MILITARY SPECIFICATION

HOSE ASSEMBLIES, NON-METALLIC: GREASE GUN HIGH AND LOW PRESSURE

This amendment forms a part of MIL-H-3868F, dated 9 December 1985, and is approved for use by all Departments and Agencies of the Department of Defense.

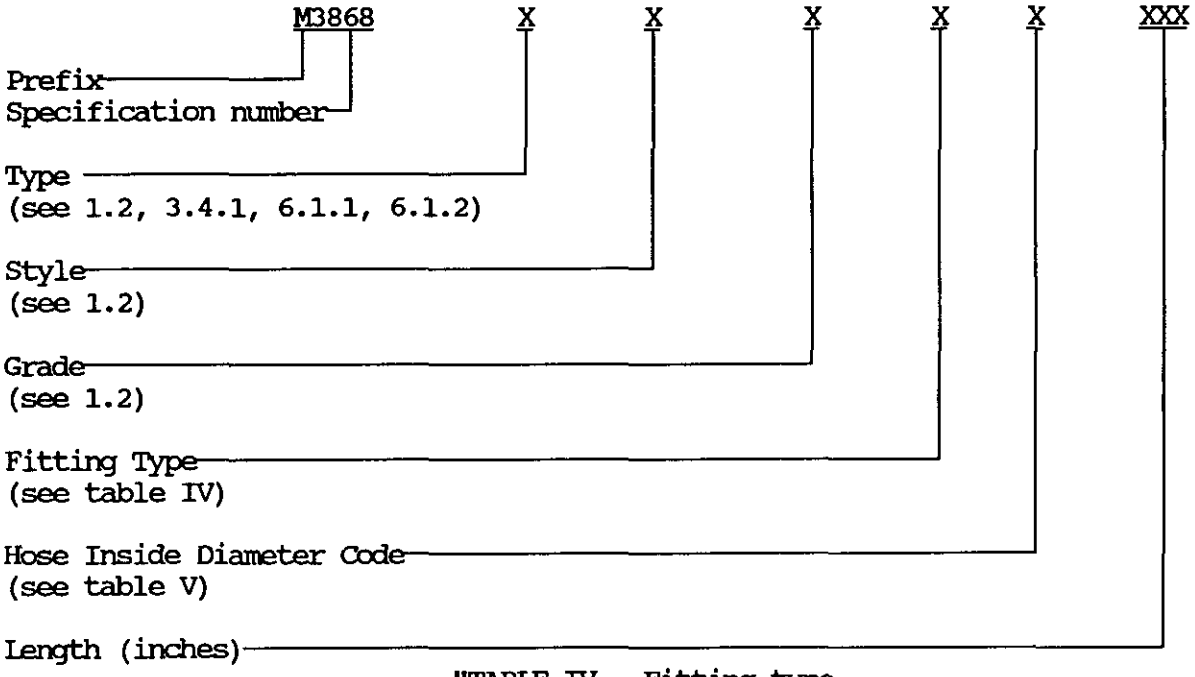
* Add the following new paragraph:

"6.5 Part or Identifying system. The part or identifying number (PIN) of hose assemblies covered by this specification shall be designed in the following form (see 3.8 and 6.2).
